Santa Ana River Wasteload Allocation Model Update

BASIN MONITORING PROGRAM TASK FORCE

November 16, 2017

Response to Comments on TM No. 1

Figure 31

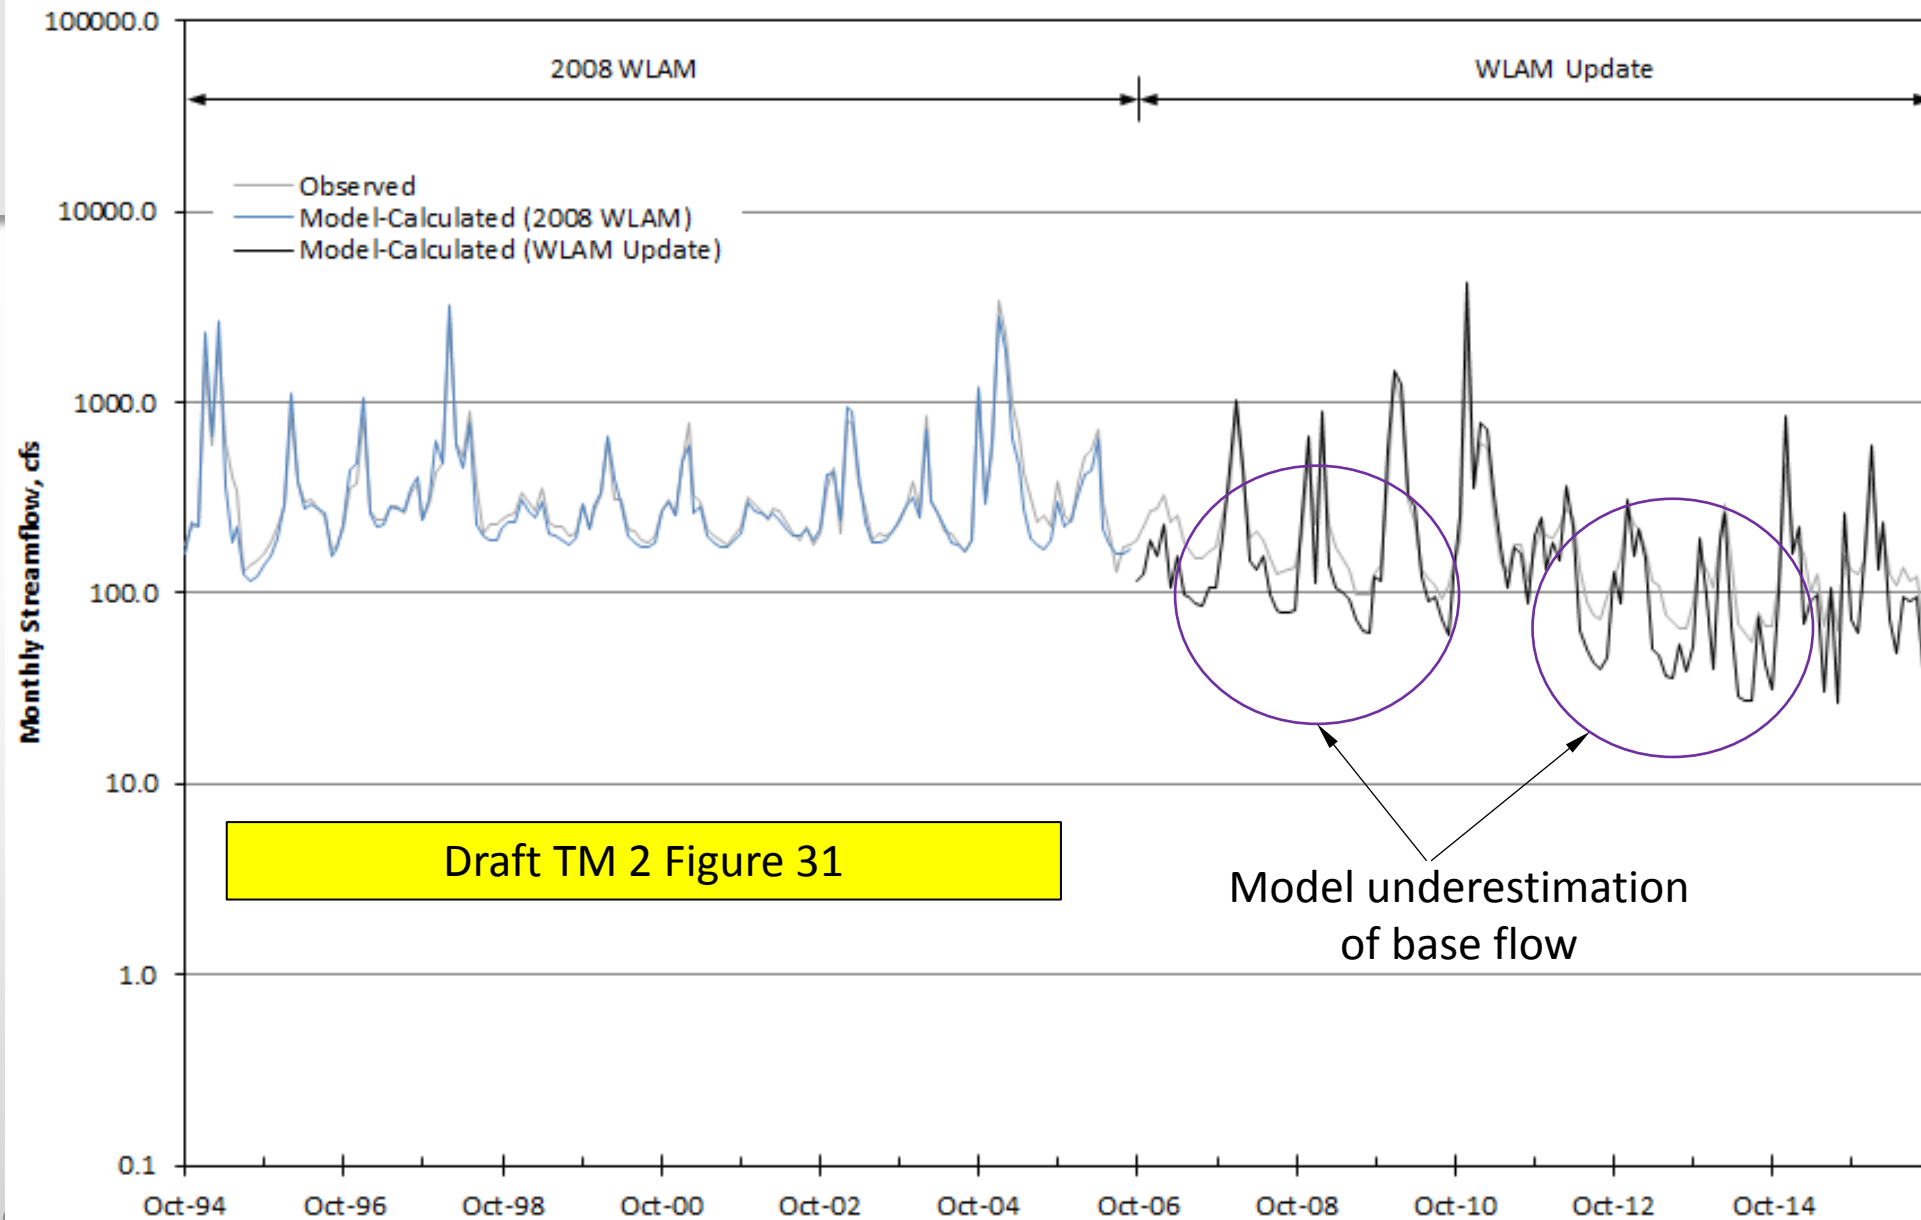
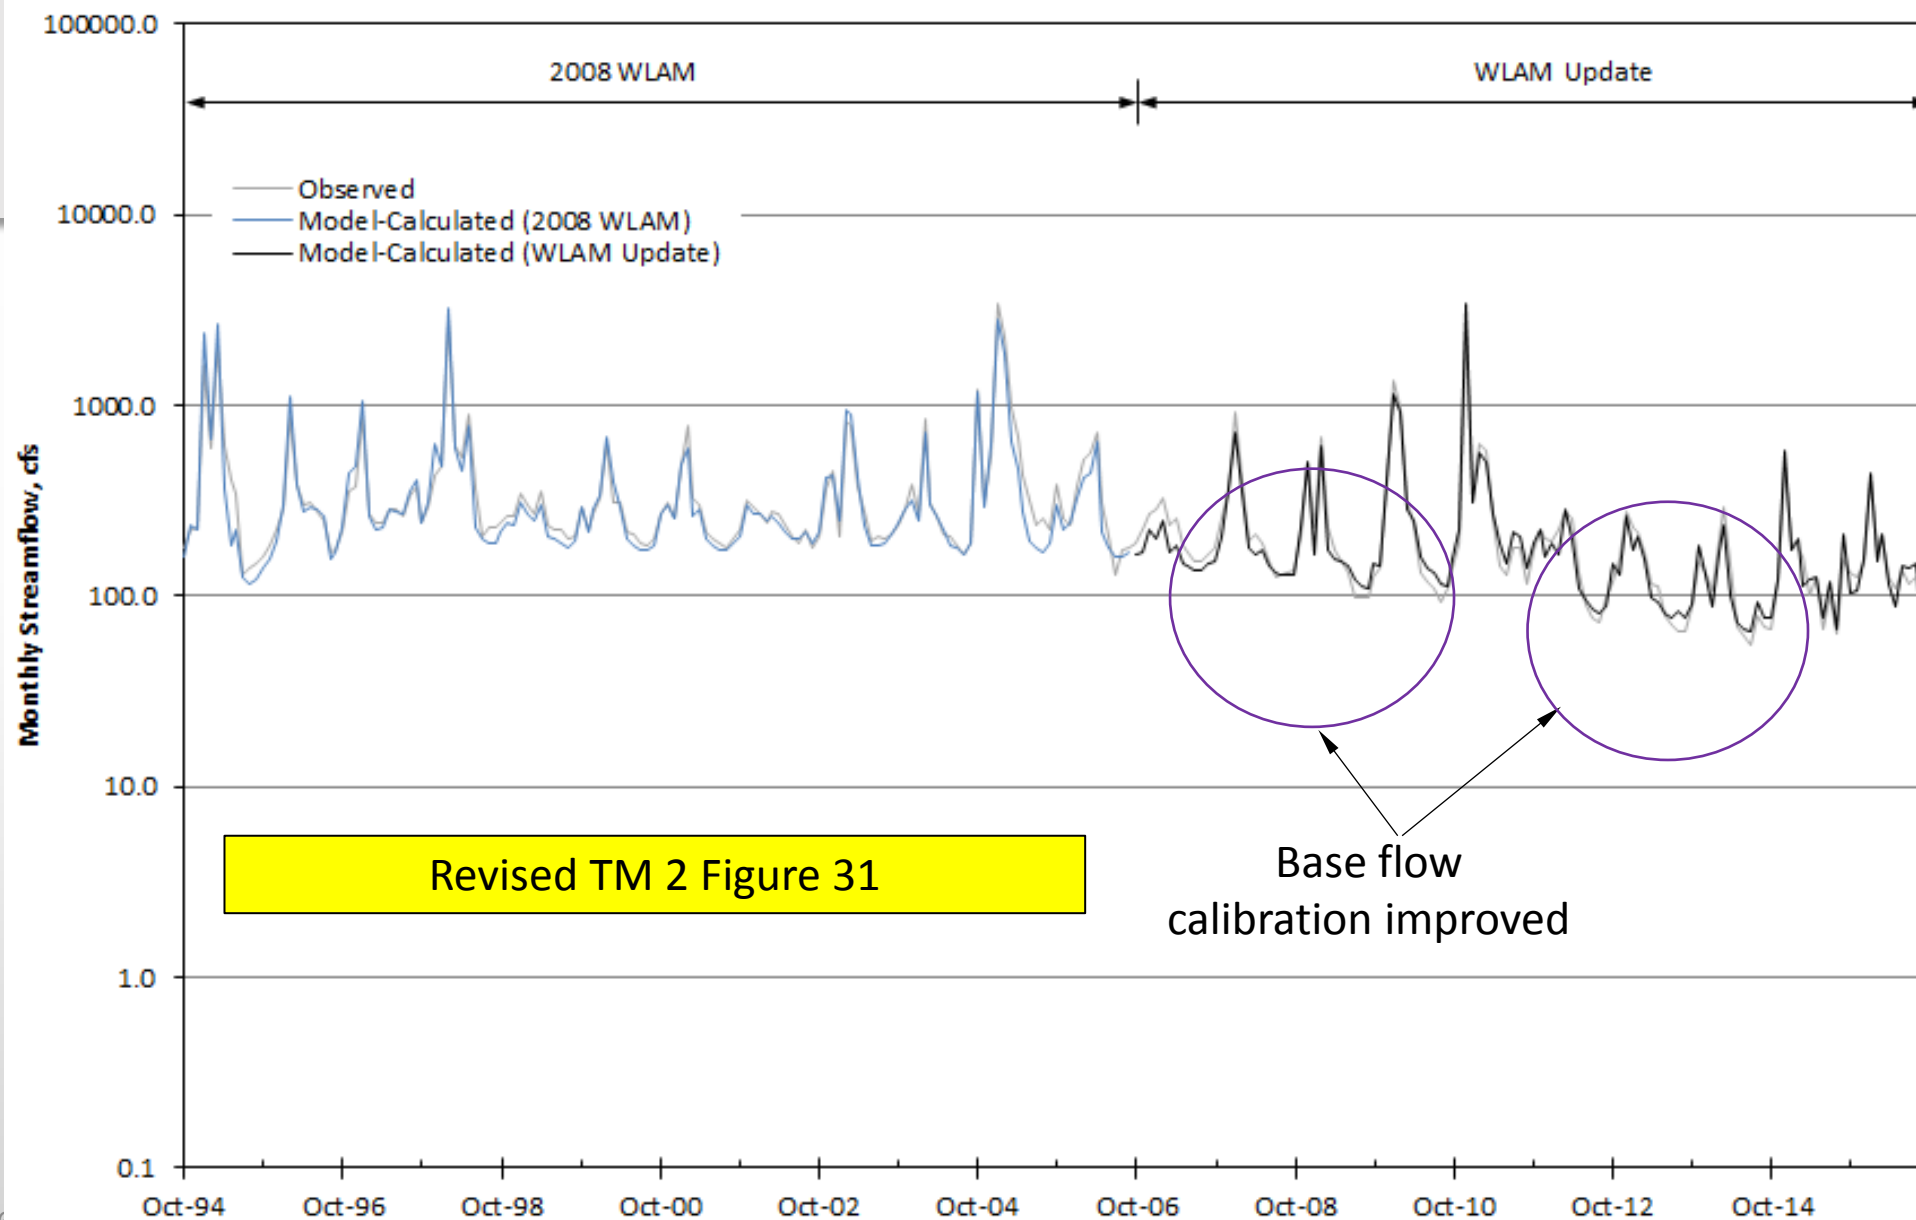
No.	Section	Pg.	Comment	GEOSCIENCE Response
9	3.3	15	Section 3.3, Streamflow Calibration Results – in the table on page 15, the monthly streamflow calibration is listed as ‘very good’ for both the 2008 WLAM and the WLAM Update for the Prado Inflow – in looking at Figure 31, the 2008 WLAM calibration result is noticeably better than the WLAM Update – since (1) Prado Dam is where runoff in the upper Santa Ana Watershed collects before flowing to the lower Santa Ana Watershed, (2) Water Quality Objectives are identified for Reach 2 and 3 in the Regional Board’s Basin Plan, and (3) Reaches 2 and 3 are demarcated at Prado Dam, additional attention should be given to the WLAM Update calibration results at Prado Dam. OCWD is not yet ready to use the WLAM Update for assessing future conditions until more evaluation is given to the calibration shown in Figure 31.	Model calibration at Prado Dam was revisited.
